# PERMIT

## SEWAGE DISPOSAL SYSTEM

**HOWARD COUNTY HEALTH DEPARTMENT**

SUBDIVISION Jack Ryan Property LOT 1 ROAD 410 Morgan Station Road

LOCATION DRAWING

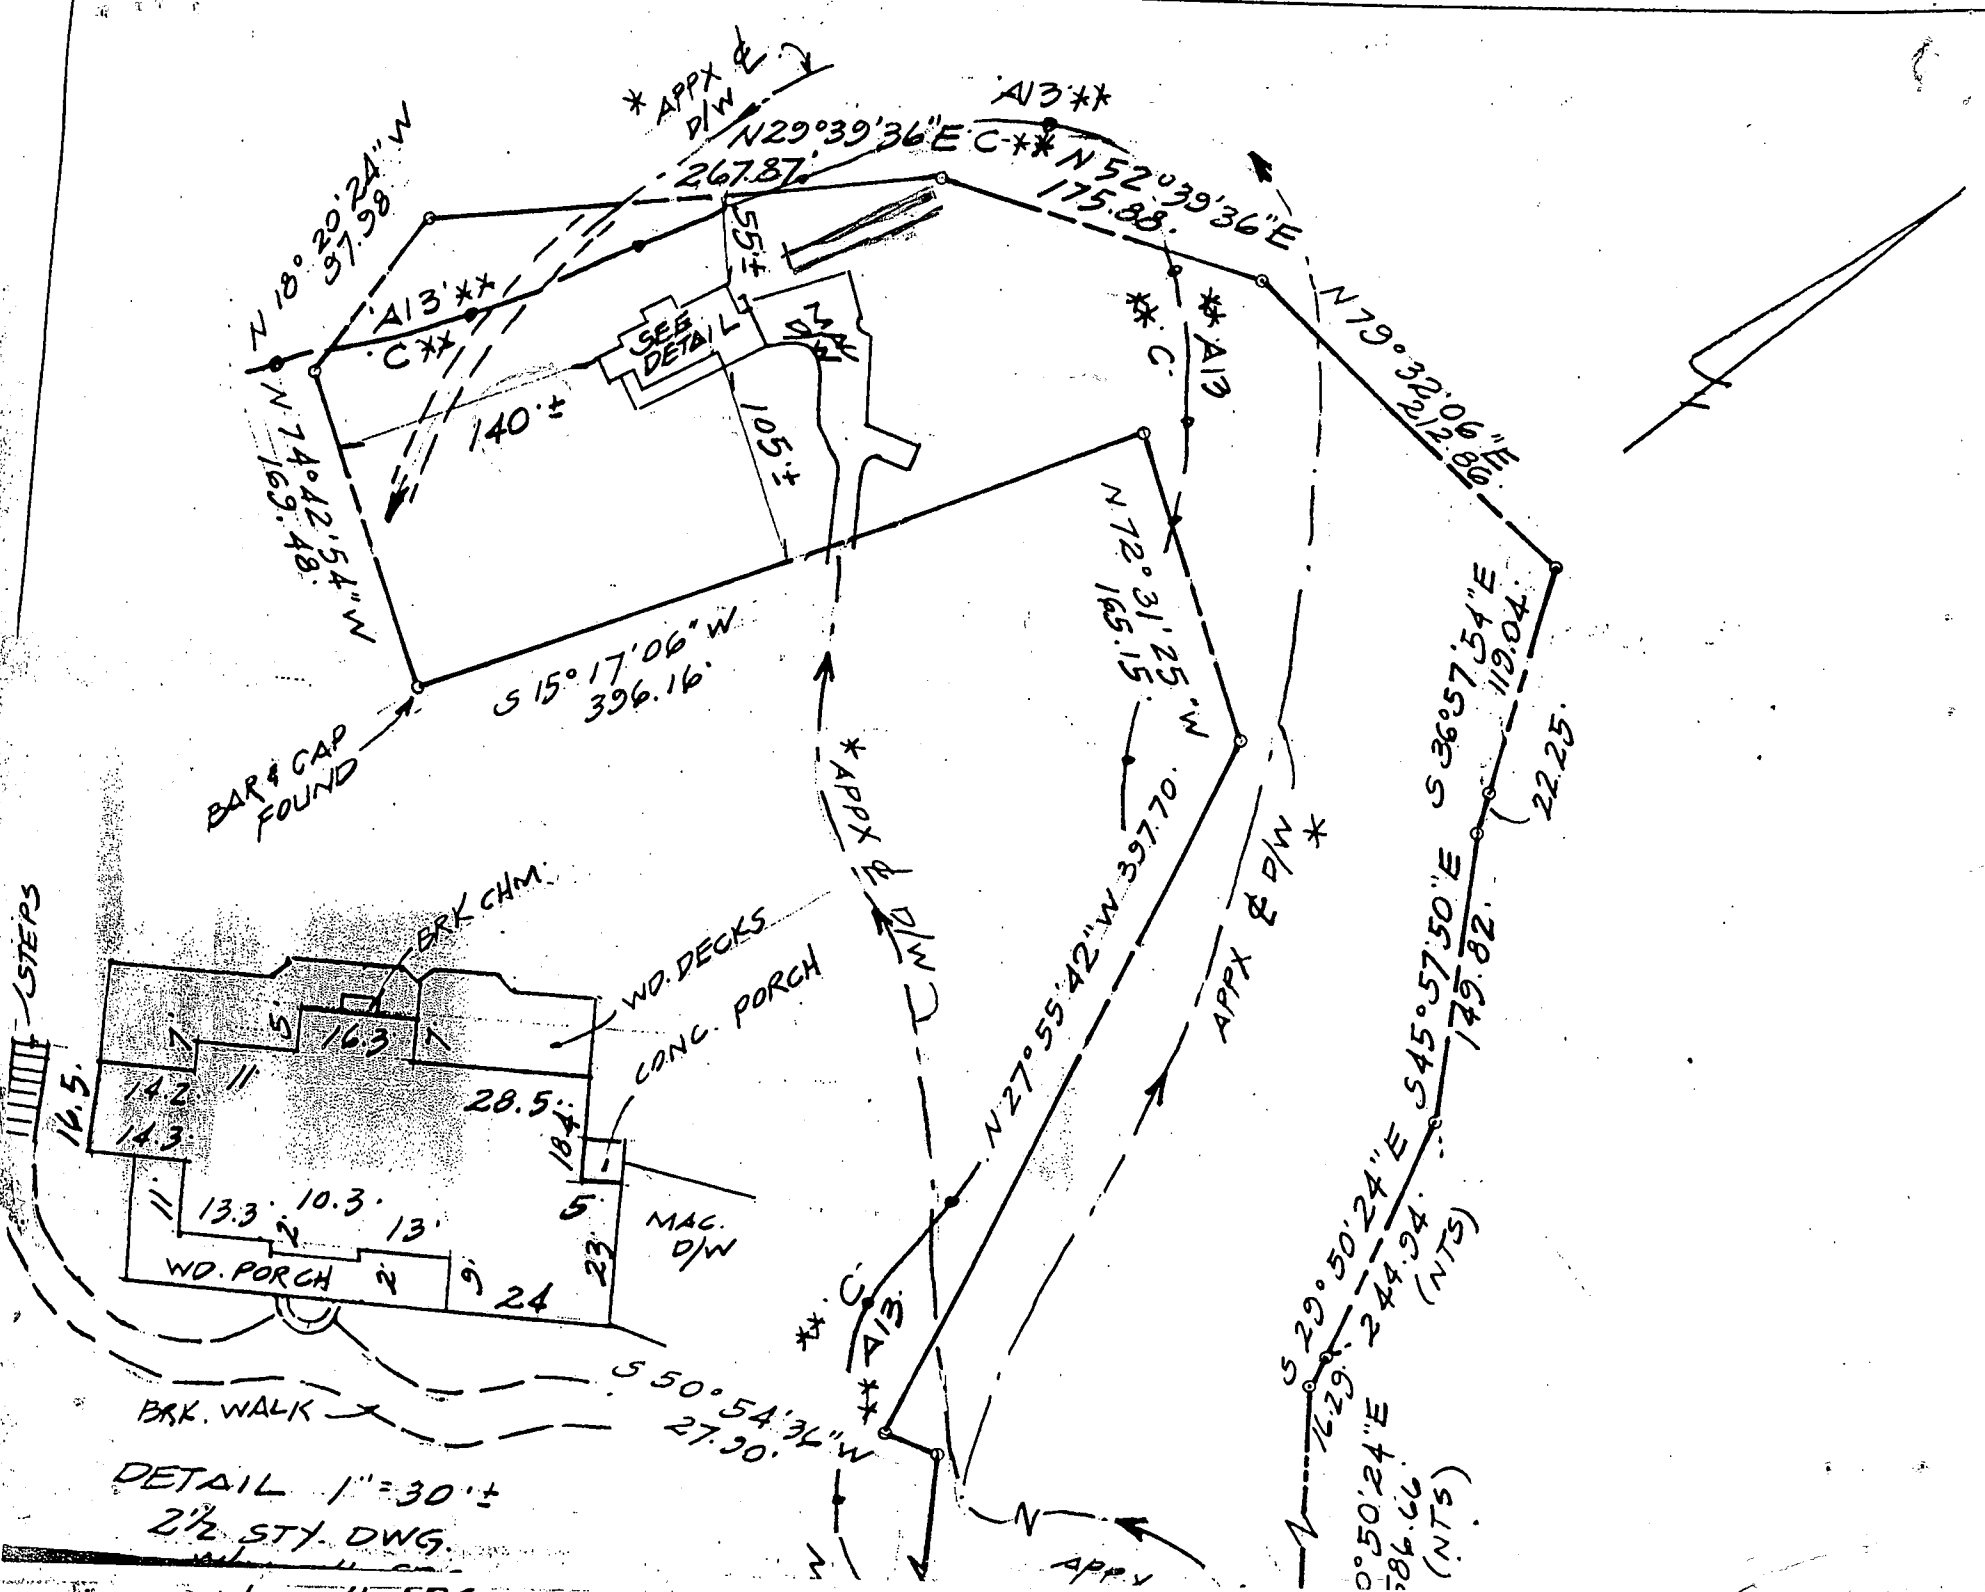
A subsequent location drawing prepared by J.S. Dallas Surveyors in December, 2000 shows a house constructed on the property, but at a location which is 140' from the southern (169.48') lot line and 105' from the western (267.87') lot line. This would appear to place the house downhill and northwest of the approved house location shown on the approved site plan of March 8, 1996, and downhill and southwest of the approved sewage easement.

Based on this review, the sewage easement has been minimally impacted by the adjusted house location, but this conclusion is subject to confirmation by a licensed surveyor. Therefore, based on Health Department requirements, adequate opportunity appears to exist to propose a pool anywhere to the south or west of the existing house.
